European garden character, with practical family choices.

Prepared by Austin Archuleta | 6506 Farmdale Lane, Austin, TX 78749

This revision

Collective Creative Outdoors September 3 revision, L-101 reference.

The supplied concept and its technical scope.

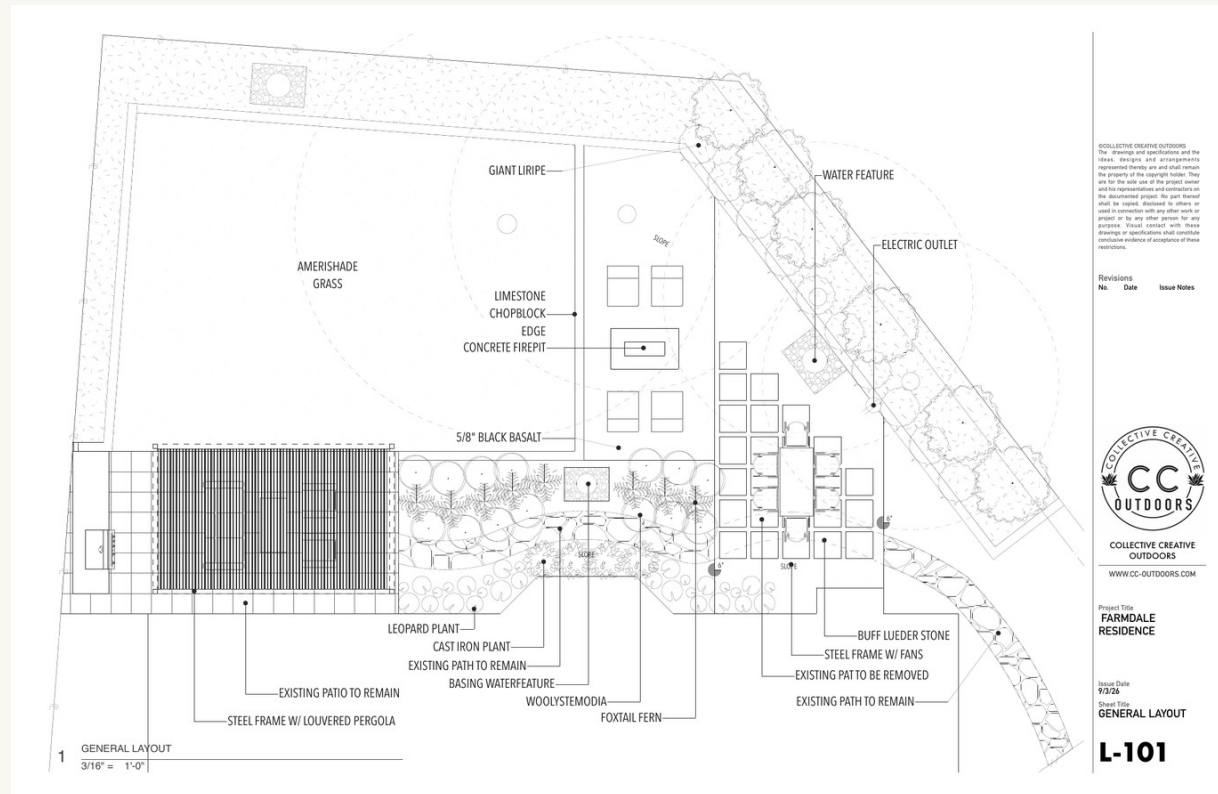
Covered patio, shaded social spaces, planting, lighting and water features are coordinated in plan. The revision adds dimensions, drainage notes and another viewpoint.

Existing/proposed elevations, exact path ties, retaining sections, root effects, base excavation and the drain outlet still need development. Two 6-inch annotations do not resolve the site fall.

The supplied concept coordinates spatial uses and materials. Existing/proposed grades, root interfaces, structural supports and drainage construction details remain unresolved.

A and D test the firm's spatial direction. B, C and E-H are owner comparison studies, not claims that a contractor can build them without further design.

Coordinate the low roof, window and new cover.

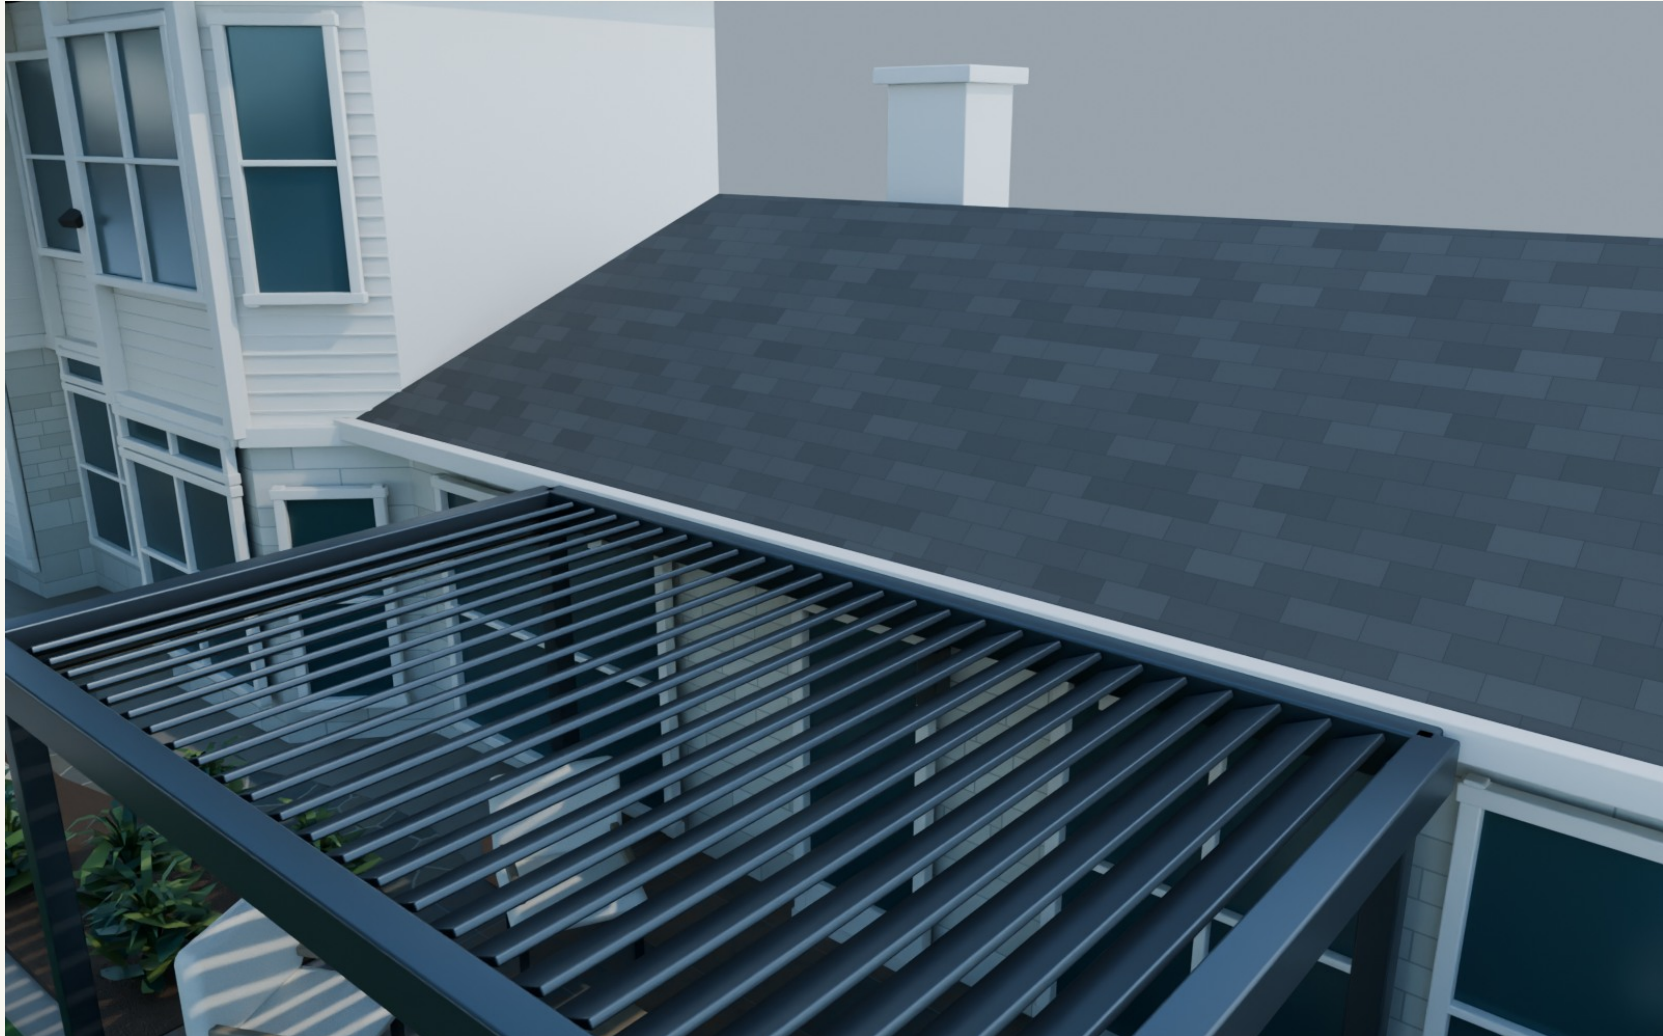
Existing roof and facade reconstructed from photos; the low eave and window relationship are explicit design checks.

Trial model heights: low existing eave 2.50 m (about 8 ft 2 in), ridge 4.25 m (about 13 ft 11 in), pergola 8 ft. These are visual assumptions, not site measurements.

Confirm roof/eave, gutter, door and window heights before selecting the pergola. Show the roof junction, flashing or separation, runoff route and connection detail. The modeled attachment and clearance are not approved.

Lawn, beds and edges

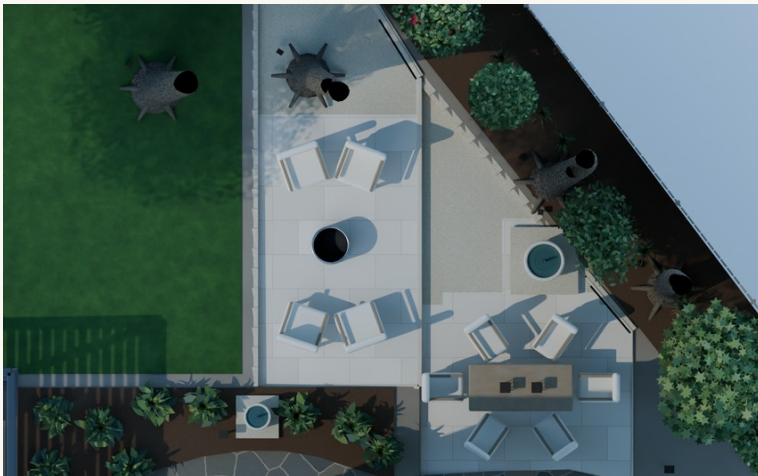
Two level pads cut into uphill soil and rise above lower soil. Resolve both perimeter interfaces; tree 02 lies inside the upper footprint. Do not excavate that conflict as drawn.

Linked deck + planted tree beds - conditional earthwork

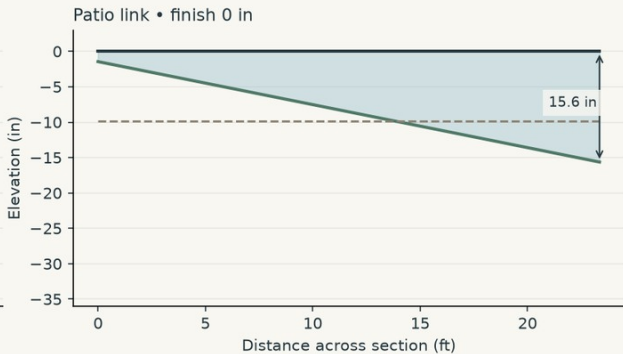
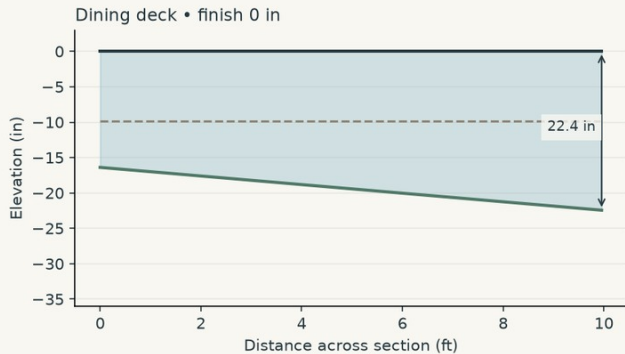
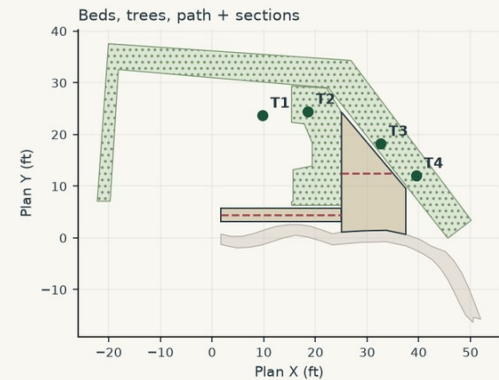
OPEN SPACE UNDER THE DECK
Air gaps are not fill volumes.
Floor: patio datum (0 in)
Framing envelope: 9.8 in below floor
Envelope-conflict cut: 0.46 yd³
Footing excavation: unknown
Total project earthwork: unknown

Full-footprint 9.8-in underside test.
This is a clearance screen only.
Actual framing / ground clearance
may require more excavation.

Lawn, beds and edges

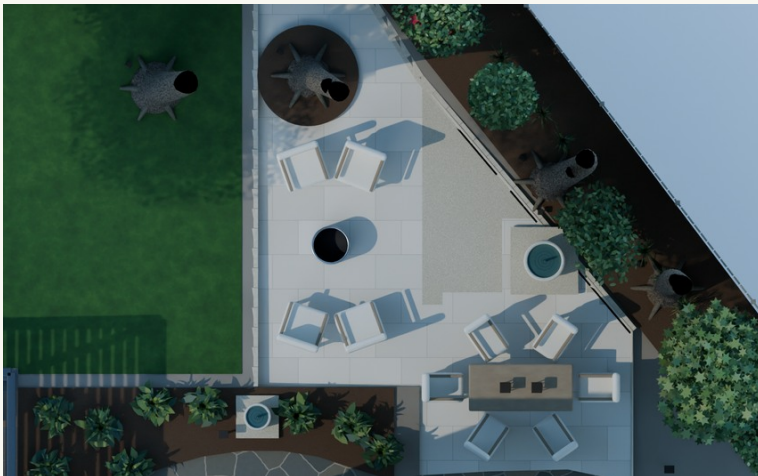
One finish removes the step between gathering areas, not the need to support outer edges. The graphic tree opening is not a root protection limit; preserve measured tree soil.

Lawn, beds and edges

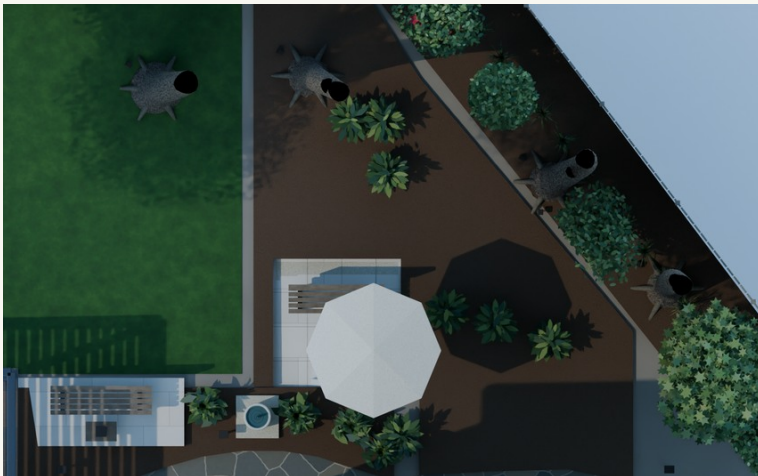
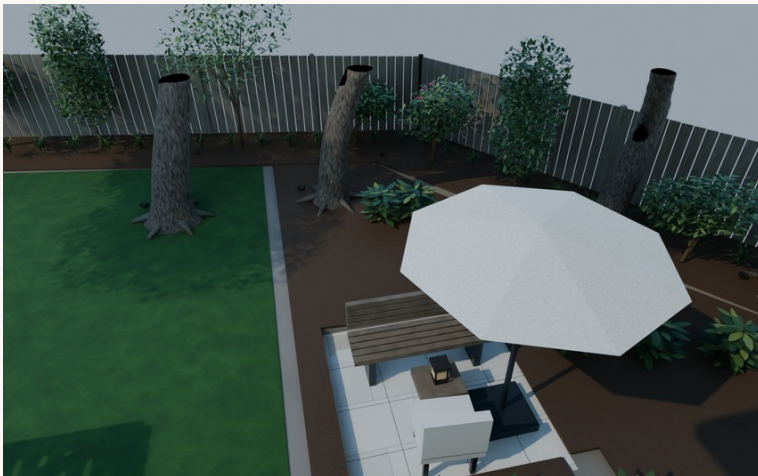
The patio-level extension can need support over falling ground. Check its outer edge and the lower nook separately; keep tree and bed soil at existing levels.
